2RF-169 -FED 128 AST FACILITY ID fVV2206936015

C147/Closure Cost/Conditions of Approval/Correspondence

Re: 2RF-169 - FED 128 AST FACILITY ID FVV2206936015 | O-21-23S-31E | Eddy Co., NM

Subject: 2RF-169 - FED 128 AST FACILITY ID [fVV2206936015]. Conditions of Approval

RECYCLING CONTAINMENT DESIGN DRAWINGS

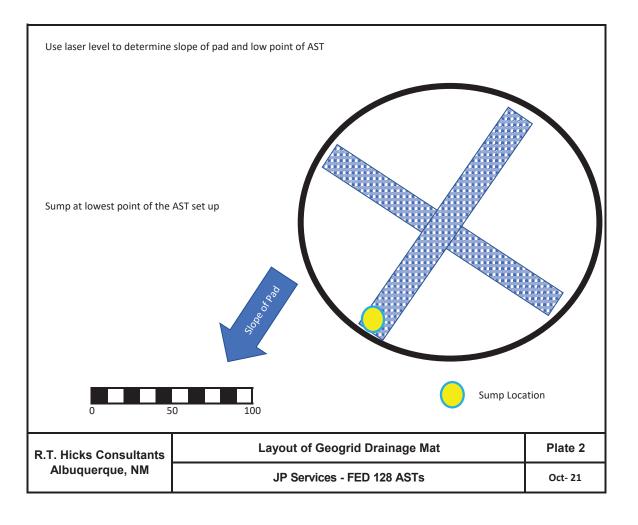
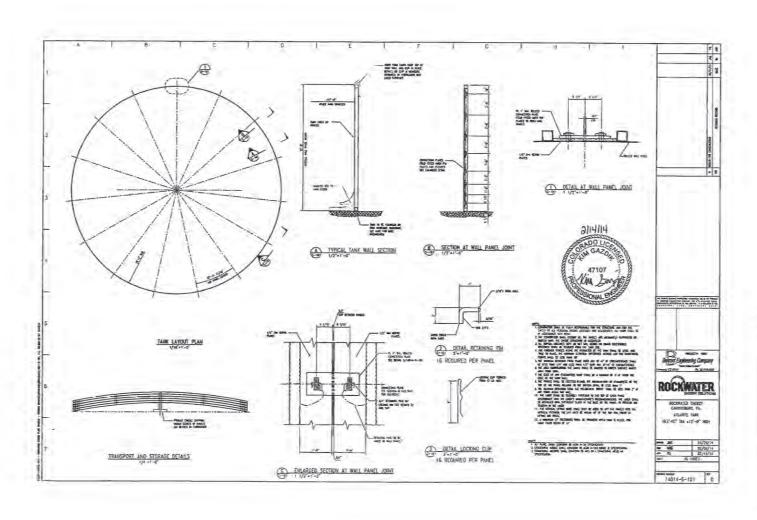
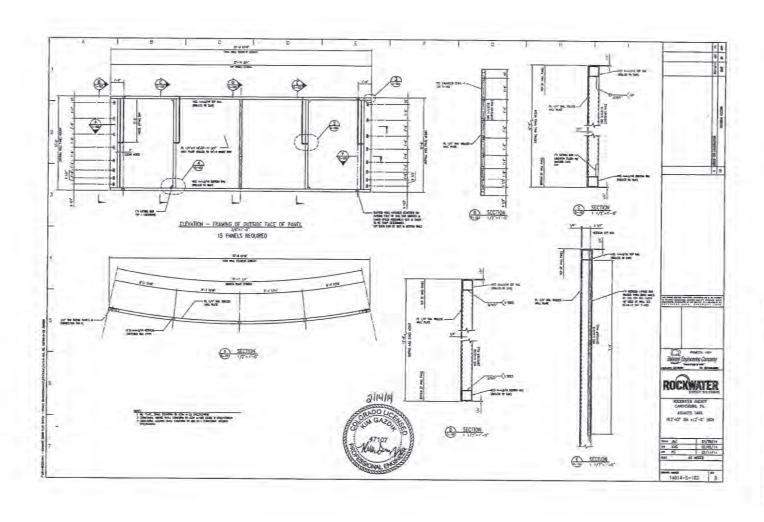
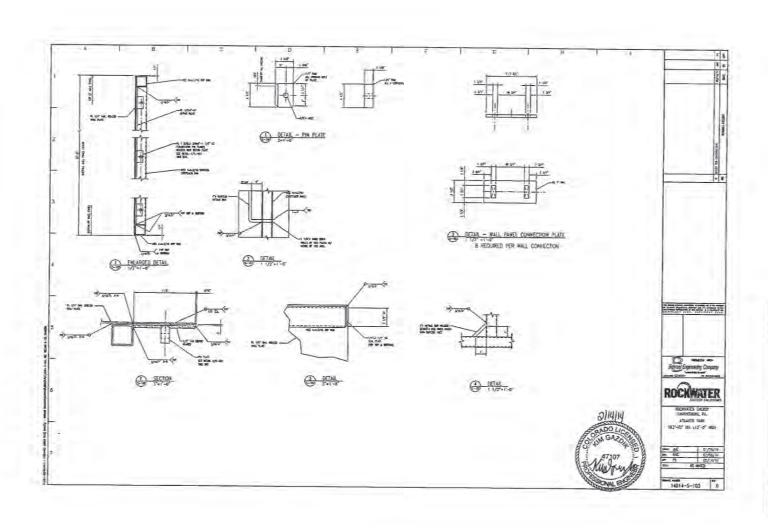
Provide the fluid capacity of each tank. Also include engineering drawings for the tanks. The drawings included in the application are completely illegible.
